## Model Error Resolution Document

1. Originator: Carlos Jove-colon/David C. Sassani	2. Date: 02/26/2008	3. ERD No. ANL-EBS-MD-000045 ERD 01
4. Document Identifier: ANL-EBS-MD-000045 Rev 03		5. Document Title: In-Drift Precipitates/Salts Model

This Error Resolution Document (ANL-EBS-MD-000045 ERD 01) is for the model report *In-Drift Precipitates/Salts Model* (ANL-EBS-MD-000045 Rev 03) to correct errors reported by the Condition Reports listed below, or identified in the document during the corrective actions being performed.

Output DTN: MO0701EQ36IDPS.000, file: *Linke binary1.zip, cano32ev.xls*.  
Figure 7-23. Solubility and Deliquescence *RH* Predictions vs. Data for  $\text{Ca}(\text{NO}_3)_2$

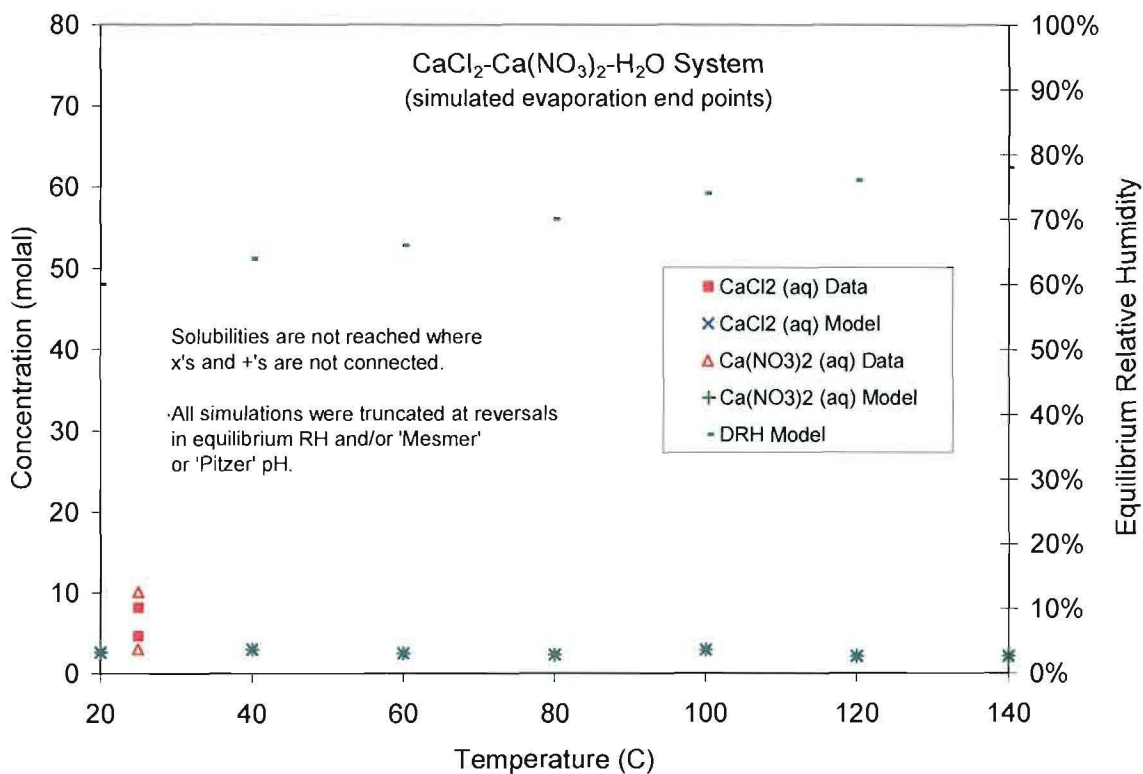
- The note below Figure 7-23 cites file kcano32ev.xls instead of cano32ev.xls. This is a typo. The correct file is now cited in the corrected figure (included below). Because the data did not change, this issue does not affect the report or its conclusions. This is corrected to read “cano32ev.xls” in the note under the Figure 7-23 as shown below.

Figure 7-46. Model Predictions vs. Data for Ca-Cl-NO<sub>3</sub> Eutectic System

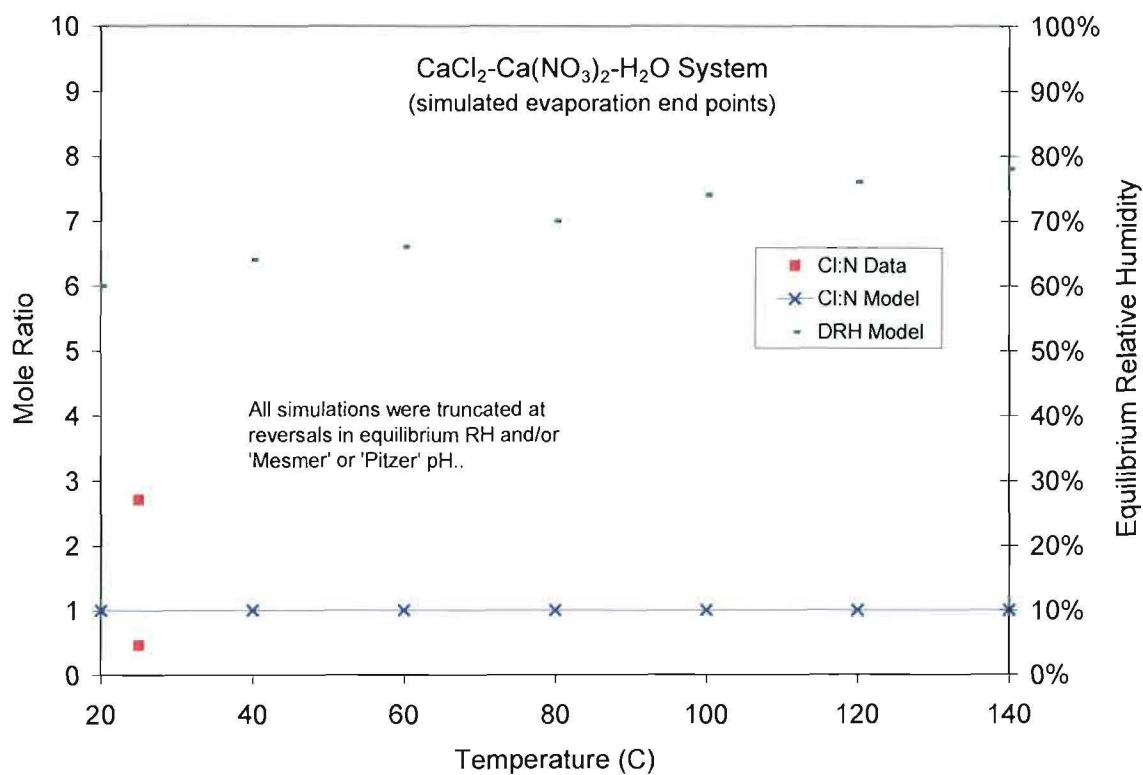
To address the above issues within the IDPS model report (ANL-EBS-MD-000045 REV 03), Figures 7-46 and 7-47 (ANL-EBS-MD-000045 REV 03) were modified with the results at the appropriate truncation points and to include a note that these simulations were to be truncated where a(w) reverses directions or where there is a reversal in pH. The updated figures are given above in the text, as well as in the DTN MO0701EQ36IDPS.000. Additionally, a specific note was added to the readme file for this DTN as listed below.

Truncating the Ca-Cl-NO<sub>3</sub> ternary system simulations at the point where a(w) reverses directions results in different end points on Figure 7-46, except for the simulation at 140°C, which showed no a(w) reversal but showed an unexpected inflection at a(w)~0.78 and a reversal in 'Pitzer' and 'Mesmer' pH values. However, even with these truncated results, there is very little difference in the model predictions at 20°C when compare to experimental data at 25°C. Thus, agreement between model simulations and experimental data is sufficient to satisfy model validation criteria and there is no impact on model validation or limitations. (The updated Figure 7-47 does not show any differences).

Figure 7-47. Cl:NO<sub>3</sub> Mole Ratio Predictions vs. Data for Ca-Cl-NO<sub>3</sub> Eutectic System

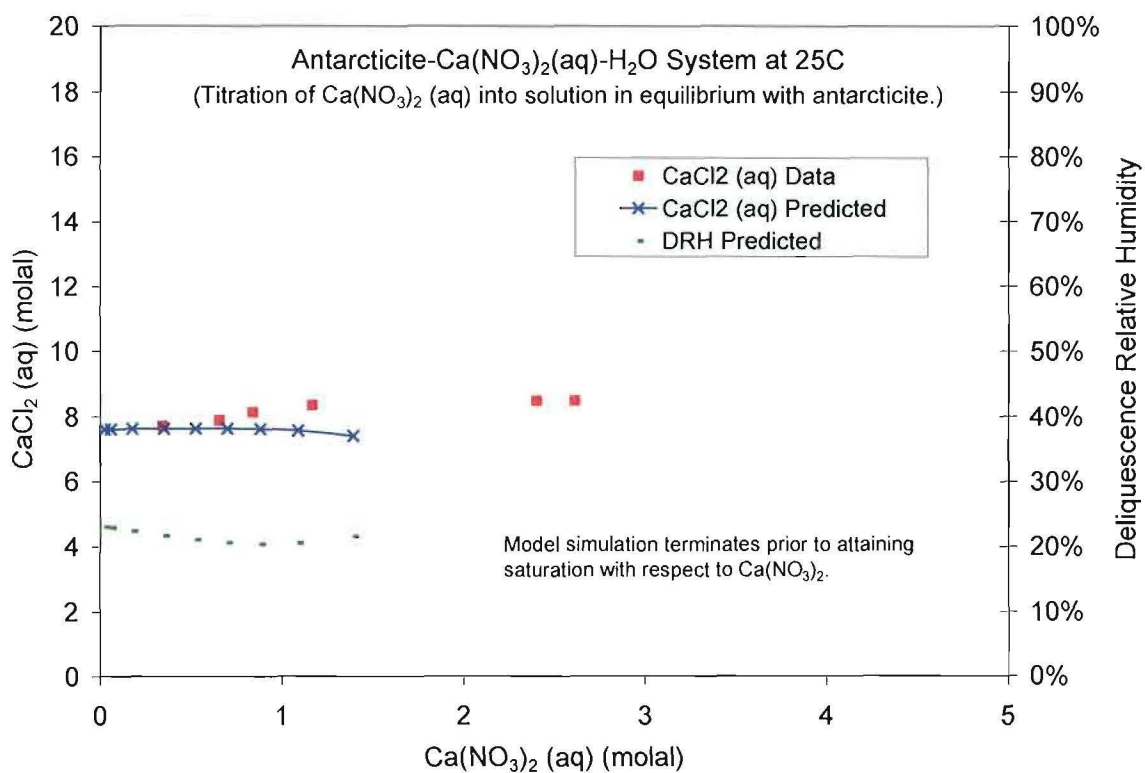
- The note below Figure 7-47 cites file kcln91.xls instead of cacln91.xls. This is the wrong file from the DTN; however, the correct file from the DTN can be discerned from the figure and the DTN readme file. The correction to the footnote of Figure 7-47 is shown below. The fix is replacing the file name ‘kcln91.xls’ with ‘cacln91.xls’. This does not affect the report or its conclusions. The correction to the footnote of Figure 7-47 is shown below.

Figure 7-48.  $\text{CaCl}_2$  Solubility Predictions vs. Data as a Function of  $\text{Ca}(\text{NO}_3)_2$  Concentration at 25°C

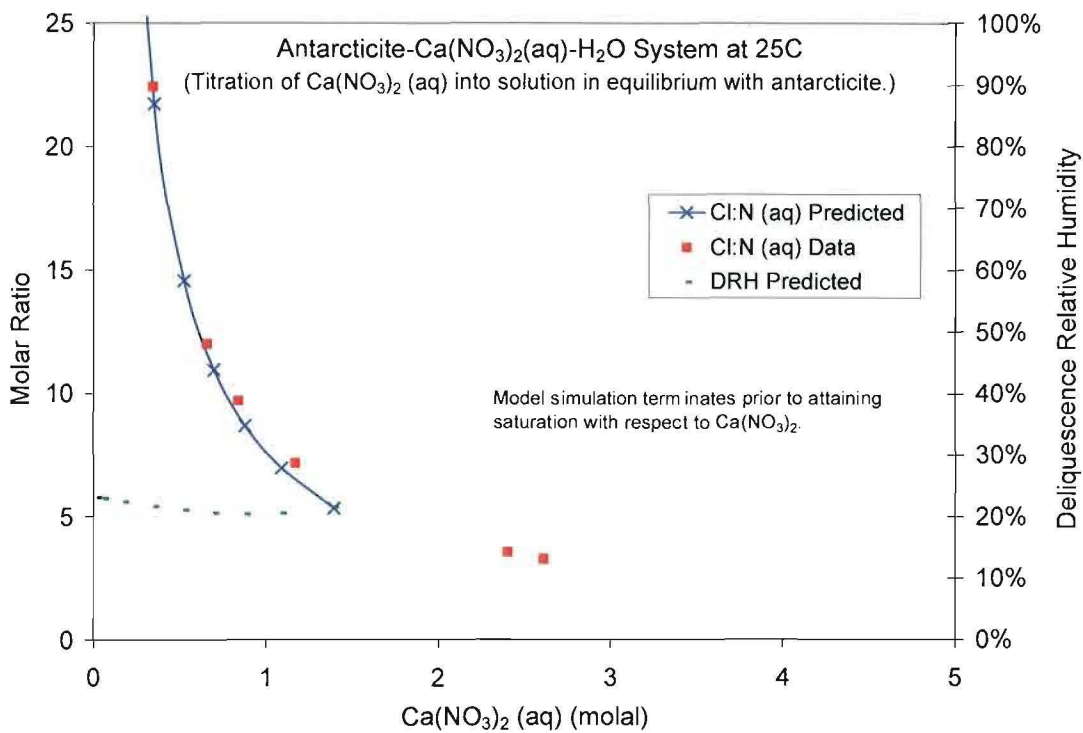
- Figures 7-48 through 7-51 have incorrect captions. The captions for 7-48 and 7-49 should have been switched with those for 7-50 and 7-51 (or the figures switched). This can be discerned from the descriptions in the figures themselves and can be confirmed by the sources listed. This error does not affect the report conclusions since premature termination of the run is acceptable in accord with validation purposes and validation criteria. The fix to switched captions for figures 7-48 through 7-51 is shown below.

- Figures 7-48 and 7-49 include notes that say the model reaches saturation with respect to  $\text{Ca}(\text{NO}_3)_2$  at 1.4 molal. These notes are incorrect. Instead, the model terminates at 1.4 molal prior to saturation with respect to this phase. However, premature termination is acceptable for validation purposes (p. 7-8 ANL-EBS-MD-000045 REV 03). Model validation includes comparisons of experimental data to model results regardless of how the simulations terminate. As long as the differences between simulated end points and experimental data are within validation criteria (which they are in this case), validation criteria are met. Therefore, this does not affect the report or its conclusions. To correct this, the notes in Figures 7-48 and 7-49 stating the model reaches saturation with respect to  $\text{Ca}(\text{NO}_3)_2$  at 1.4 molal have been removed, and the statements in these notes have been replaced with the following “Model run terminates prior to attaining saturation with respect to  $\text{Ca}(\text{NO}_3)_2$ ”. The corrected Figures 7-48 and 7-49 are shown below and in the revision to DTN MO0701EQ36IDPS.000.

Figure 7-50. Ca(NO<sub>3</sub>)<sub>2</sub> Solubility Predictions vs. Data as a Function of CaCl<sub>2</sub> Concentration at 25°C

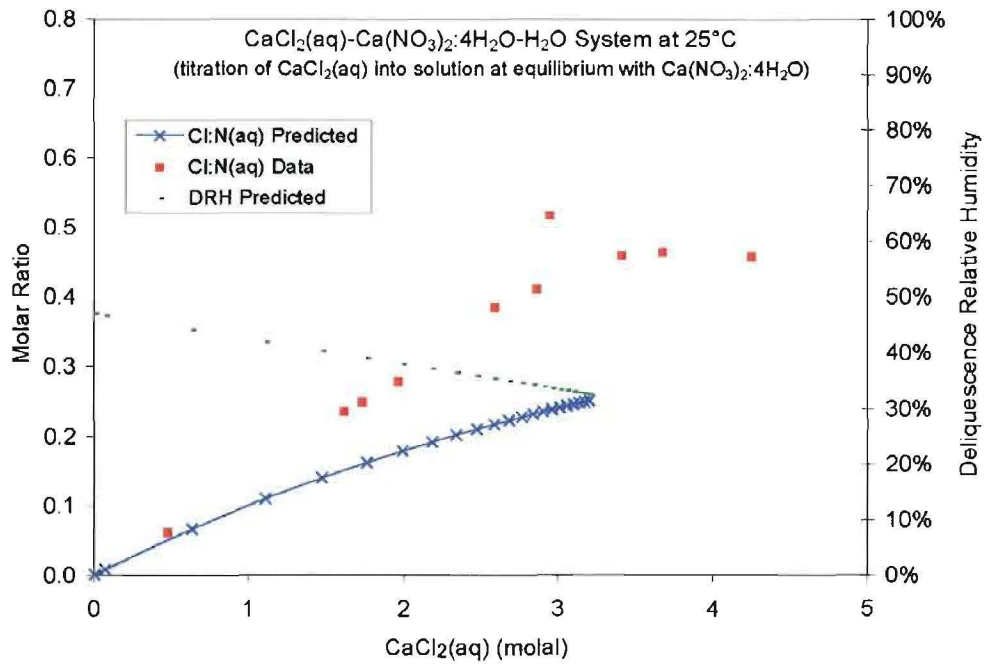
4. The source file for Figure 7-50 should be "cacln25.xls". The caption in Figure 7-50 for the source spreadsheet file has been corrected to read "cacln25.xls" as shown below.

Figure 7-5. Solubility and Deliquescence *RH* Predictions vs. Data for CaCl<sub>2</sub>.

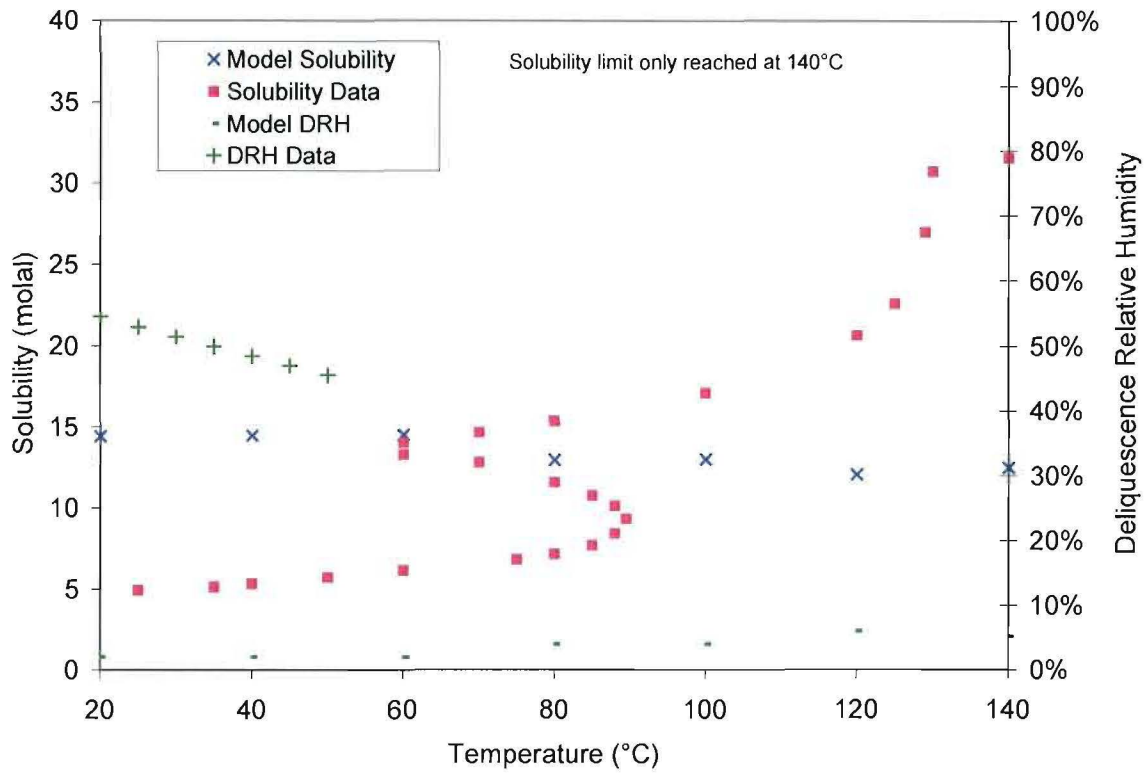
1. The line segment connecting the 120°C and 140°C results in Figure 7-5 should not be present because the solubility limit was not achieved in the 120°C result. This is a note error because a note in the figure states "Solubility limit not reached where x's are not connected." To correct this, the line segment connecting the symbols for the 120°C and 140°C results in Figure 7-5 has been removed consistent with the note in the figure about not reaching solubility limits. The corrected Figure 7-5 is shown below and in the revision to DTN MO0701EQ36IDPS.000.

Figure 7-24. Solubility and Deliquescence RH Predictions vs. Data for  $Mg(NO_3)_2$ .

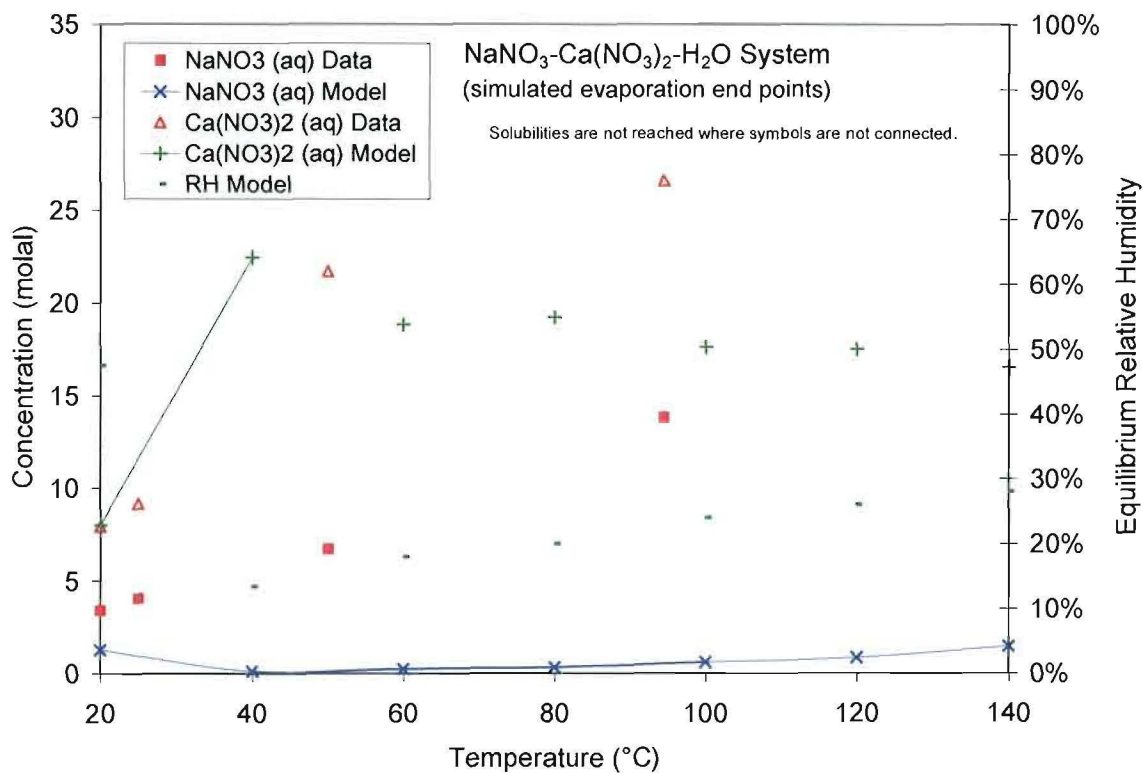
2. The note in Figure 7-24 that the solubility limit was not reached over the entire temperature range is wrong; it was reached at 140°C. The notation is corrected to read "Solubility limit only reached at 140°C". The corrected Figure 7-24 is shown below and in the revision to DTN MO0701EQ36IDPS.000.

Figure 7-40. Model Predictions vs. Data for Na-Ca-NO<sub>3</sub> Eutectic System

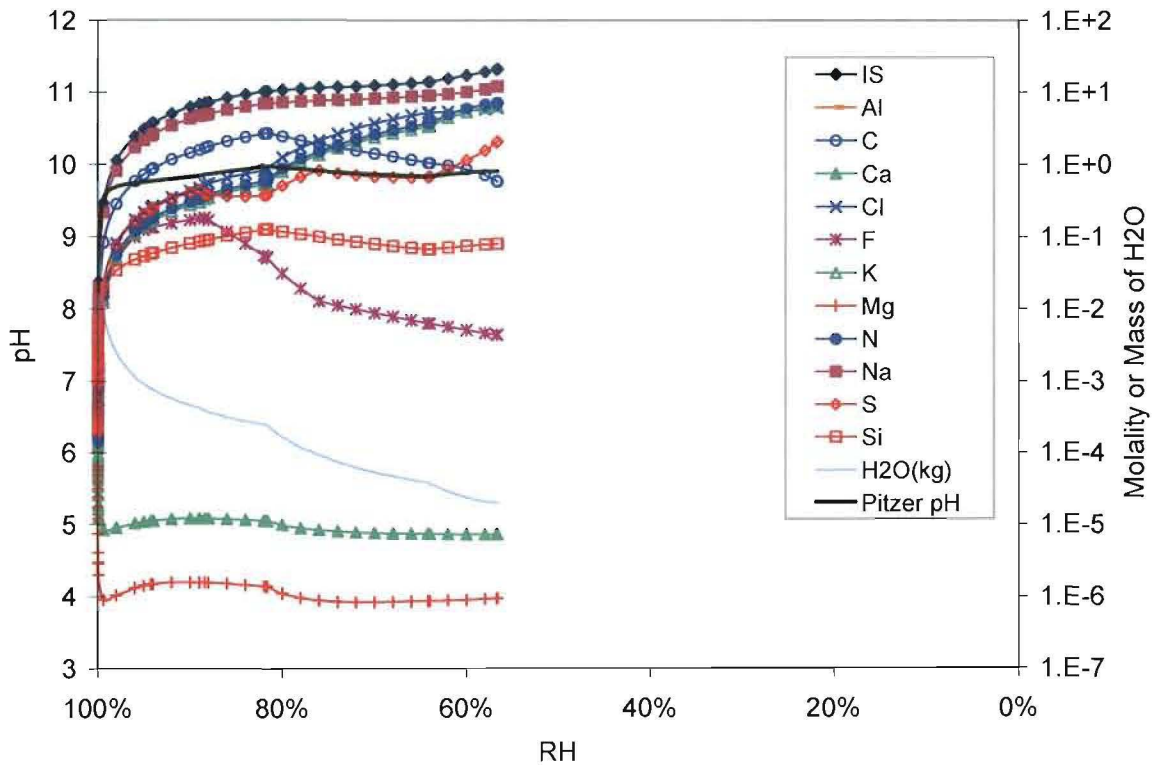
3. There should be a line segment connecting the symbols for the 20°C and 40°C model results for  $\text{Ca}(\text{NO}_3)_2$  in Figure 7-40 to indicate saturation with respect to  $\text{Ca}(\text{NO}_3)_2$  at 20°C and 40°C. The note in the figure should state that "Solubilities are not reached where symbols are not connected." Figure 7-40 has been modified to correctly depict the data representing saturation conditions. The note in the figure has been modified to reflect this as well and is shown in the corrected Figure 7-40 below and in the revision to DTN MO0701EQ36IDPS.000.

Figure 6-4. Example Aqueous Composition Evaporation Predictions vs. RH

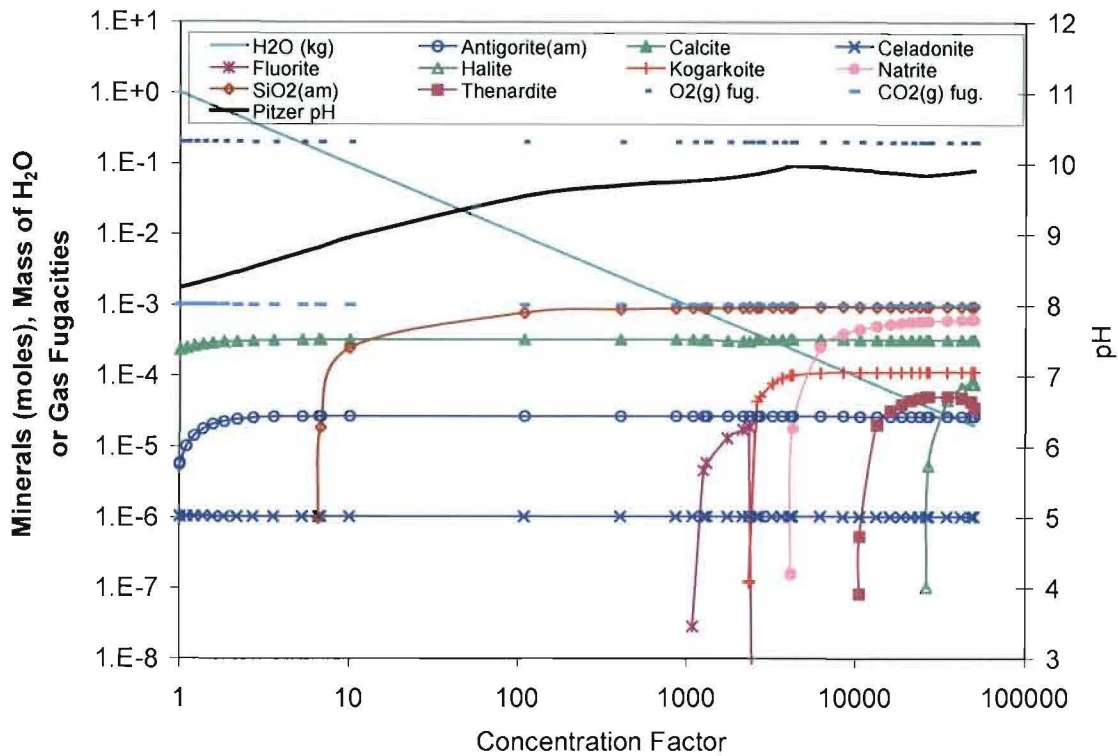
**Issue #11:** (1) Evaluation of this issue indicates that each figure in Section 6.7 (Figures 6-4 and Figures 6-7 in ANL-EBS-MD-000045, Rev. 03) does not exactly match the values in the cited DTN. Accurate figures are provided in the DTN in the files containing the calculations. These figures are for demonstration only and do not have any effect on model validation, limitations, uncertainty, or use in TSPA-LA.

(1) Figures 6-4 and 6-7 in Section 6.7 do not exactly match the data in the DTN but accurate figures can be found in the files in the DTN that contain the calculations. Therefore, this discrepancy does not impact the model results or the conclusions derived from them. The figures reflecting accurate representation of the data are already contained in DTN SN0611T0509206.006 and are shown below.

Figure 7-68. Predicted vs. Measured Concentrations for Synthetic J-13 Water Evaporation Experiments of Rosenberg et al. (1999 [DIRS 125338])

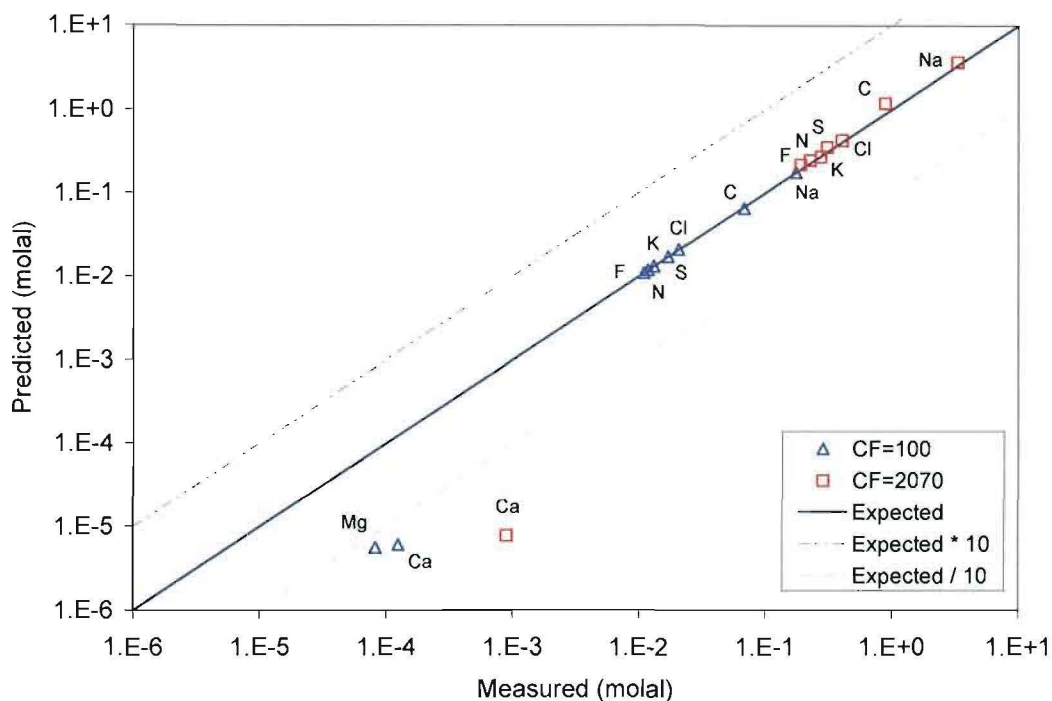
CR Description: “Figures 7-68 and 7-72 in ANL-EBS-MD-000045 REV 03 are missing labels to identify the elements for each data point. These labels apparently were lost during technical editing when converting the figures to pdf because they are not missing in the Word document drafts (at least through draft REV 03D).

**Issue #1:** *Missing labels for data points in figures 7-68 and 7-72 in ANL-EBS-MD-000045 (REV 03).*

**Evaluation:** Per the CR description, traceability is sufficient given the relevant text explanation related to the significance of these figures in the report ANL-EBS-MD-000045 (REV 03). Also, the original figures are in DTN: SN0702T0509206.008, files ‘j13n1pitpH.xls’ and ‘j13b1v3.xls’, and include the missing labels for the data points. Moreover, the figures with labeled data points that are used in SAR section 2.3.5 were obtained directly from the DTN source because they are correct. Therefore, the corrected figures 7-68 and 7-72 are given below to replace those with missing labels in the report ANL-EBS-MD-000045 (REV 03).
